Extract from our commission

The Welsh Assembly, who are providing PFI finance, have requested the County to provide an assurance that "the necessary independent technical expertise will be applied to setting and delivering the appropriate standard for remediation of the site" in response to local concerns.

In order to progress this, the Health Authority Director of Public Health has reached an agreement with the CEO of Conwy County for the Authority to procure an independent review of the proposals.

Landfill gas regime

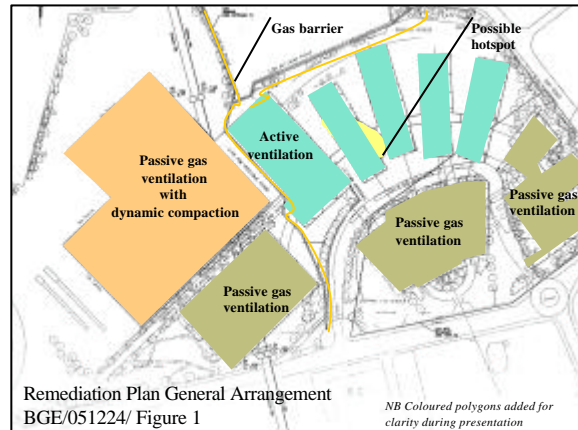
- LFG at high concentrations (69% CH₄; 21.5% CO₂)
- Inconsistent interpretation of consequences of LFG (p9 no change at perimeter due to redevelopment; p19 need for gas migration barrier between 2 schools as gas may migrate to junior school after redevelopment.)
